PLAN COMMISSION / ZONING BOARD OF APPEALS AGENDA

Project: Abbey Woods North
Meeting Type: Public Hearing
Requests: Rezoning (upon annexation), Preliminary Plat of Subdivision, relief from Design Standards for cul-de-sac length and wall length, relief from Land Subdivision Regulations for cul-de-sac length and stub street connection, review of variations for lot width & depth
Location: South side of St. Francis Road, just east of La Grange Road
Applicant: O'Malley Builders Inc.
Prop. Owner: Steven Beemsterboer
Representative: Shawn O'Malley
Staff Reviewer: Christopher Gruba, Senior Planner

ABBEY WOODS NORTH
STEVEN BEEMSTERBOER
9433 ST FRANCIS ROAD FRANKFORT, ILLINOIS
PRELIMINARY PLAT

LANDSCAPE PLAN - PARKWAY TREES

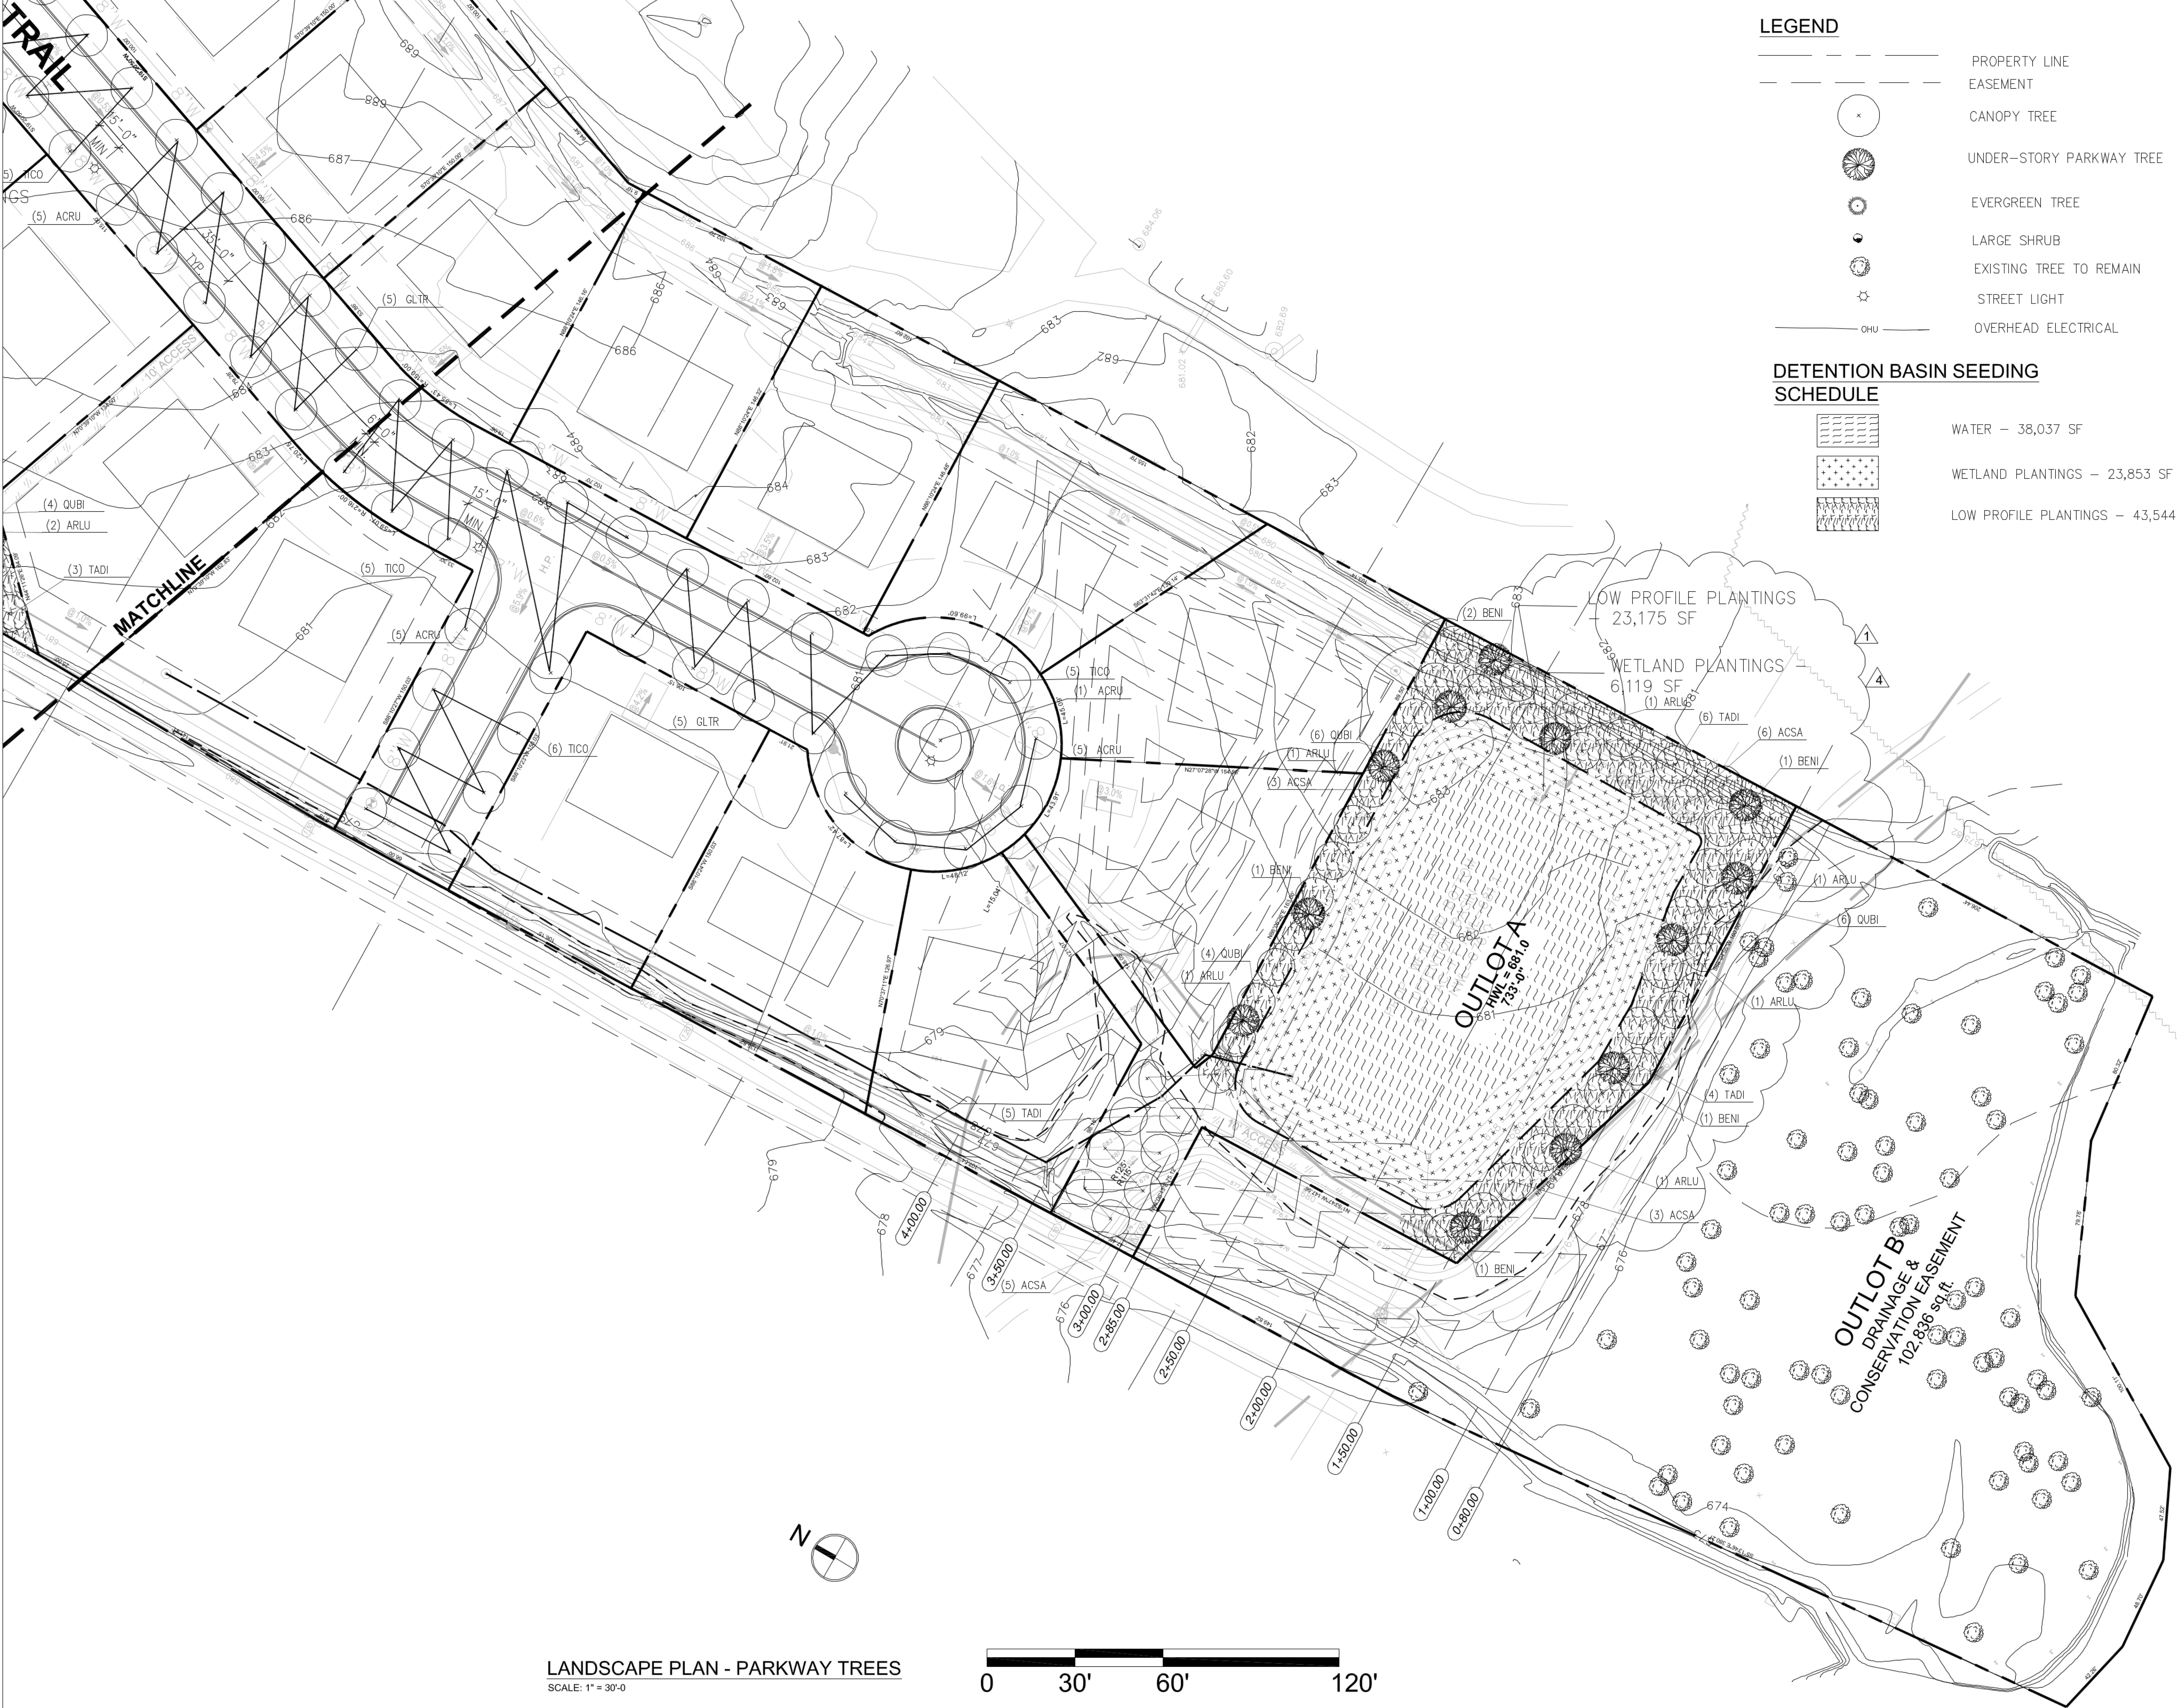
5. The Landscape Plan has been corrected to illustrate vegetation along the landscape berm adjacent to St. Francis Road, whereas before it was illustrated within the actual road right-of-way and not permitted. The Landscape Plan was received on April 5th, so staff did not have time to review the entire plan for compliance with the Landscape Ordinance in time for this report.

1. Landscaping adjacent to an Arterial Road (St. Francis): A 25' wide, 3' tall, landscaped berm is required along the length of St. Francis Road. This berm must contain "125 plant units" per 100' of lineal frontage and at least 40% of the plant units must be evergreen. A 3' tall berm is provided along the entire length of St. Francis Road, although there are two gaps east of the proposed Waterview Trail extension, but these have been provided for drainage. The Landscape Ordinance does permit exceptions when the berm would conflict with drainage, as in this case. This 25' landscape berm is located in a 25' wide "no fence, no access" easement, to ensure no fences or vehicular (driveway) connections to St. Francis Road.

2. Street Trees (Parkway Plantings) along the Waterview Trail extension: One (1) overstory tree is required for every 35' lineal feet of road frontage. The Landscape Plan notes that three (3) different tree species will be provided for the street trees. The total number of street trees provided complies with this code requirement.

3. Landscaping around the perimeter of stormwater detention facilities: Twenty (20) plant units are required for every 100' lineal feet of perimeter around each pond, measured at the high-water level (HWL). It appears that the proposed pond landscaping has been placed above the high-water level.

In summary, the landscaping requirements appear to have been met for the landscape berm, parkway plantings and around the detention pond. However, it's uncertain whether enough mitigation trees have been placed on site to offset the removal of preservation trees. The Landscape Plan was received on April 5th, so staff did not have time to review the entire plan for compliance with the Landscape Ordinance in time for this report.
